Docket Item #13
BAR CASE #2004-0114

BAR Meeting
August 18, 2004

ISSUE: Addition and alterations

LOCATION: 921 South Alfred Street

Figure 1 - Rear (west) Elevation

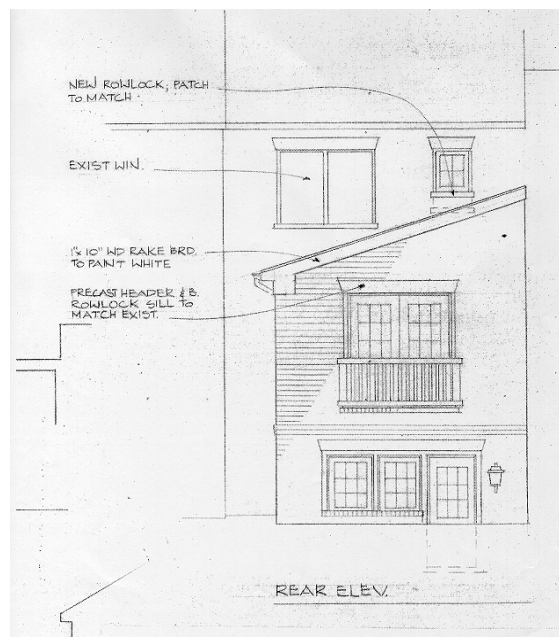
Staff does note that the proposed windows with interior grilles, but no exterior grilles, do not conform to the *Guidelines* (Windows - Page 2). The *Design Guidelines* encourage the use of true divided light windows, but do allow for the use of simulated divided light windows on rear elevations that are not readily accessible to the public. Staff believes simulated divided light windows would be appropriate for the addition at 921 South Alfred Street as it is well removed from public access and on the rear of the house. In addition, Staff notes the *Design Guidelines* call for integral shades on skylights to reduce seepage of light and recommends that this be made a condition of the approval (Skylights - Page 2).

Therefore, Staff recommends approval of the application with the condition that the windows on the addition be simulated divided light windows with fixed exterior grilles and that the skylights have integral shades.

Figure 2 - North and South Side Elevations

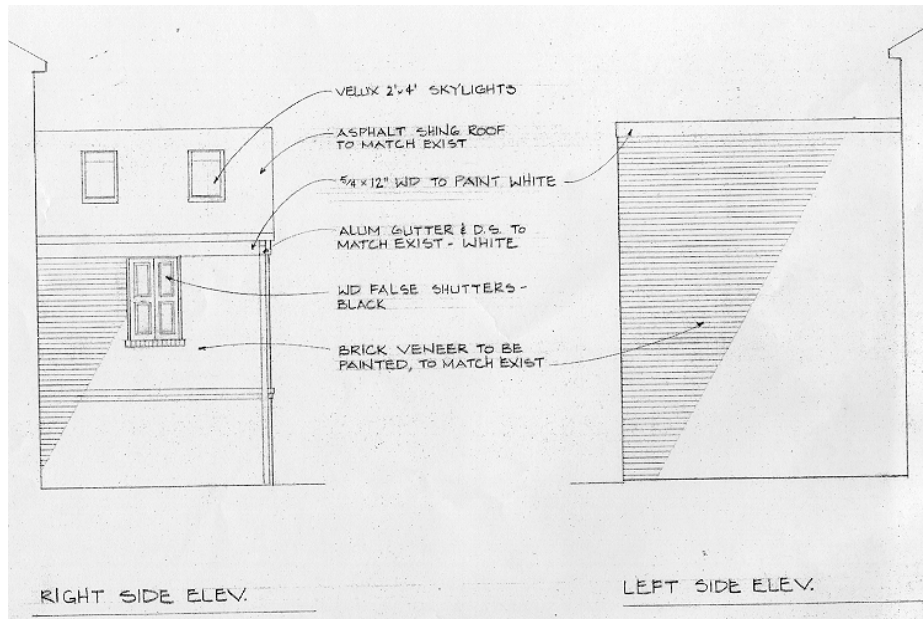
- C-1 All exterior walls within 3 feet from an interior property line shall have a fire resistance rating of 1 hour, from both sides, with no openings permitted within the wall. As alternative, a 2 hour fire wall may be provided. This condition is also applicable to porches with roofs and skylights within setback distance.
